Rezoning Application: PD 24-0293

REVISED REPORT

Request: Rezoning to Planned Development

2.4 Proposed Site Plan (partial provided below for size and orientation purposes. See Section 8.0 for full site plan)

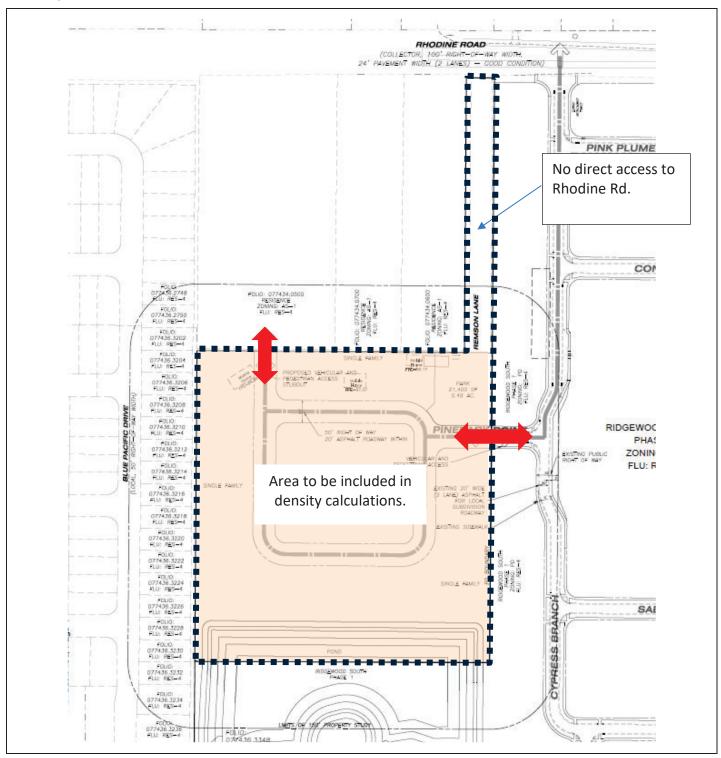
- Revise site data table to correct side and rear yards on corner lots to a minimum 15 feet.
- Revise the single headed arrow at the intersection of Cypress Branch St and Rhodine Rd. to a doubled headed arrow.
- Revise the singled headed arrow in the site plan legend to a double headed arrow and label it as "Vehicular and Pedestrian Access".
- Delete Site Plan General Notes # 25. All internal roadways to be public.
- 1. The project shall be permitted a maximum of 42 single-family detached residential dwelling units and developed according to the following development standards:

- 2. At the <u>preliminary</u> plat certification time, the 0.89 AC parcel track adjacent to Rhodine Road shall be combined with parcel #77434.0600. Otherwise, it shall be comprised by one of the project subdivision lots.
- 3. The project shall be permitted one full access connection on Pinebark Pointe Ct. as shown on the PD site plan.

- 4. The project shall stubout a roadway connection to folio #77434.0500 consistent with LDC, Sec. 6.02.01. subdivision access requirements, as shown in the PD site plan.

- 6. The subject property existing driveway, referred to in the PD site plan as Remson Lane, shall be closed and resodded on Rhodine Rd.
- 7. The developer shall construct a 5-foot sidewalk along the project frontage on Rhodine Rd.

7.0 ADDITIONAL INFORMATION AND/OR GRAPHICS

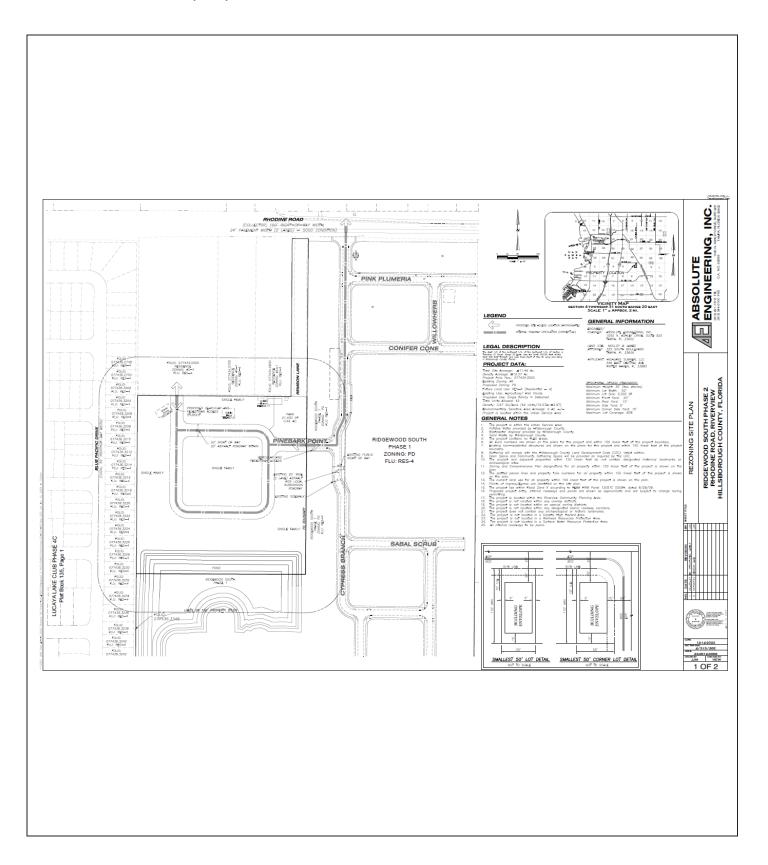
The applicant provided a revised plan after the Revised Plan Deadline. The proposed changes do not trigger a continuance to a further hearing date.

2.4 Proposed Site Plan (partial provided below for size and orientation purposes. See Section 8.0 for full site plan)

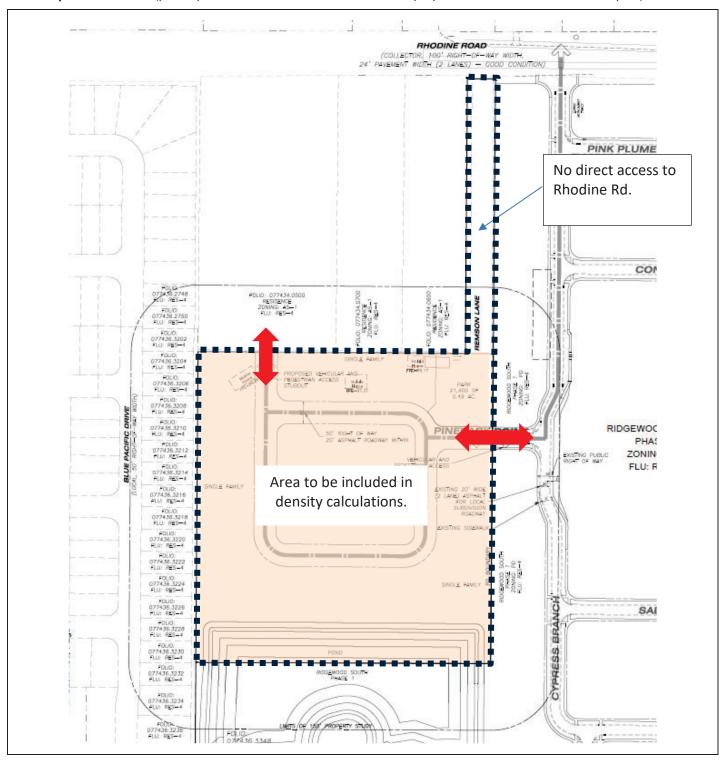
- Revise site data table to correct side and rear yards on corner lots to a minimum 15 feet.
- Revise the single headed arrow at the intersection of Cypress Branch St and Rhodine Rd. to a doubled headed arrow.
- Revise the singled headed arrow in the site plan legend to a double headed arrow and label it as "Vehicular and Pedestrian Access".
- Delete Site Plan General Notes # 25. All internal roadways to be public.
- 1. The project shall be permitted a maximum of 42 single-family detached residential dwelling units and developed according to the following development standards:

- 2. At the <u>preliminary</u> plat certification time, the 0.89 AC parcel track adjacent to Rhodine Road shall be combined with parcel #77434.0600. Otherwise, it shall be comprised by one of the project subdivision lots.
- 3. The project shall be permitted one full access connection on Pinebark Pointe Ct. as shown on the PD site plan.

- 4. The project shall stubout a roadway connection to folio #77434.0500 consistent with LDC, Sec. 6.02.01. subdivision access requirements, as shown in the PD site plan.

- 6. The subject property existing driveway, referred to in the PD site plan as Remson Lane, shall be closed and resodded on Rhodine Rd.
- 7. The developer shall construct a 5-foot sidewalk along the project frontage on Rhodine Rd.

REZONING AERIAL SITE PLAN

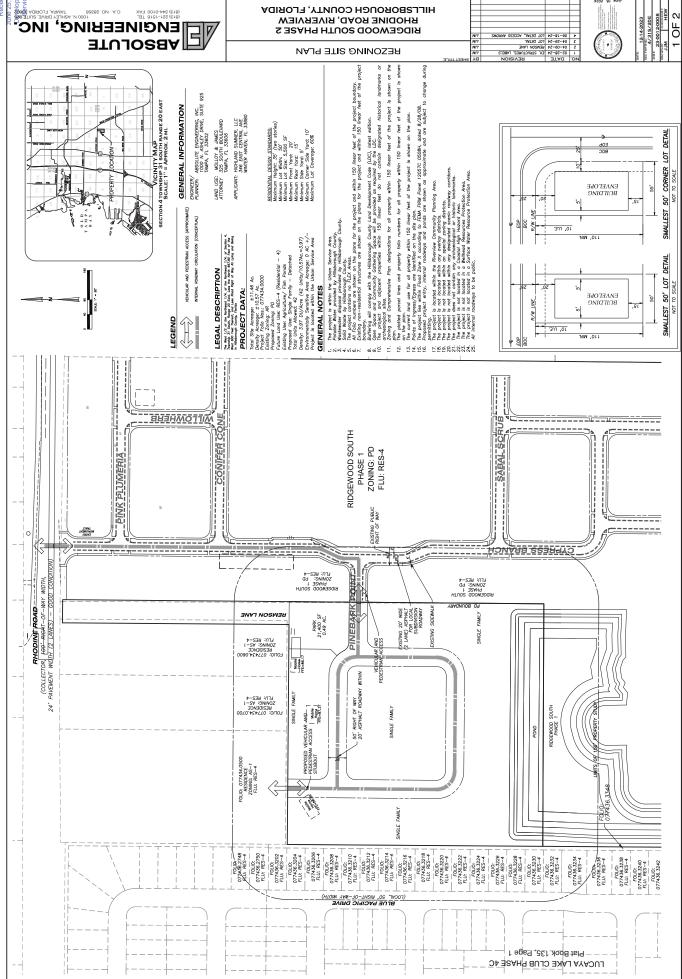
- A) Revise the single headed arrow at the intersection of Cypress Branch St and Rhodine Rd. to a doubled headed arrow.
- B) Revise the singled headed arrow in the site plan legend to a double headed arrow and label it as "Vehicular and Pedestrian Access".
- C) Delete Site Plan General Notes # 25. All internal roadways to be public.
